## Re: Gate Placement/Relocation on Forest Rd 394

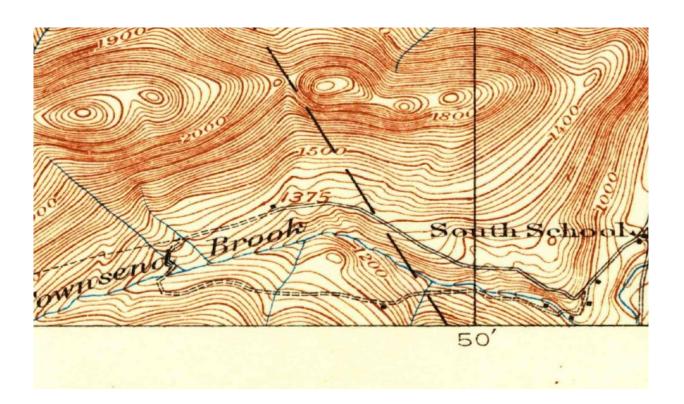
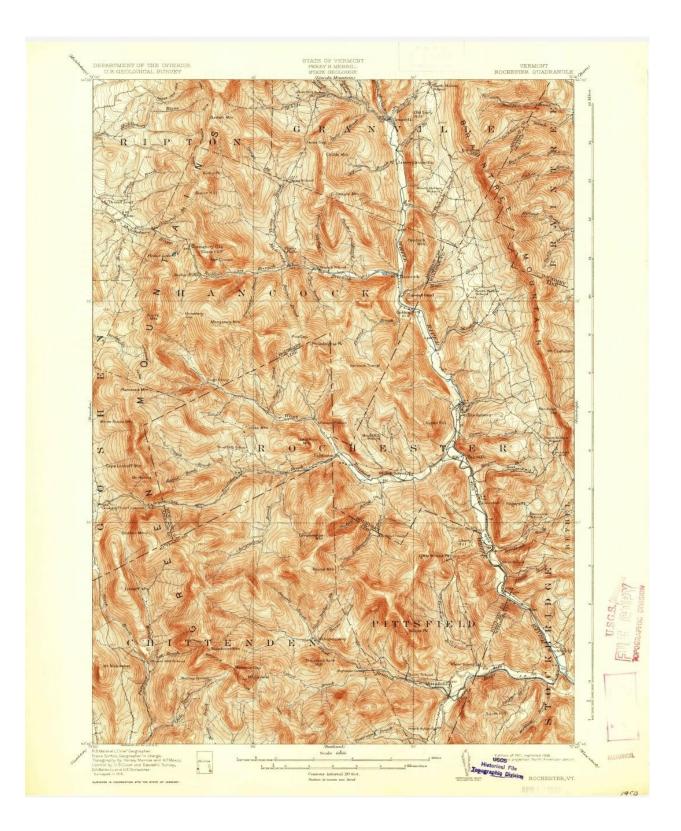
The proposed gate and parking lot at mile 1.8 would limit access to recreational activities such as hunting and fishing for people who have limited abilities or handicaps. The existing parking lot allows easier access to fishing and hunting areas with less grade. The area selected for the new gate and parking lot has steep banks/grades and limits access to fishing and hunting for limited individuals.

The existing Road continues to an parking lot that has been there for well over 100 years. It could be argued the what you have designated as a trail is actually an existing road. Topo maps from 1915 have the road continuing to meet the Tozier Hill Rd (or what was originally the Old Stage Coach Rd) on the North Side of Tozier Brook. This has been a ROAD for at least 108 years or more. Please see Maps included.

This is an important area of Recreation for many people especially those that have grown up there and are not getting any younger. This gate would limit access and be unfair to those that are limited. Please consider not wasting the money on a gate and parking lot but possibly use it to improve the road and parking lot that exists.
